Access audit report of St Katherine's Church of England Primary School

14th February 2022

T

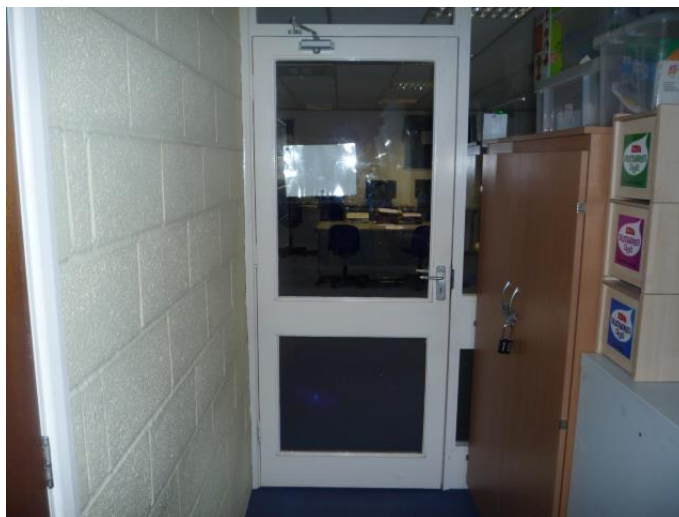
KS1 library area

a wheelchair is far easier over hard even flooring or short pile carpets, see (Image T).

DD

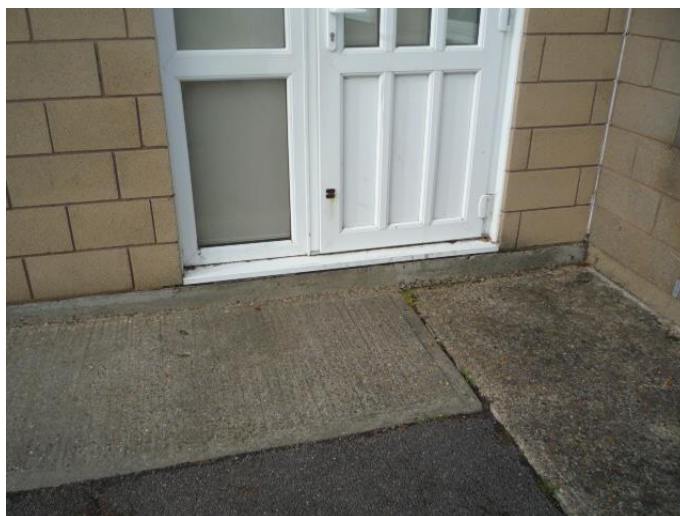
Some areas of the outside space could be improved however. The storage boxes (Images DD & EE) should be re-positioned and other equipment tidied thus ensuring the walkways remain fully accessible.

Ensure all external walkways remain clutter free **(A)**
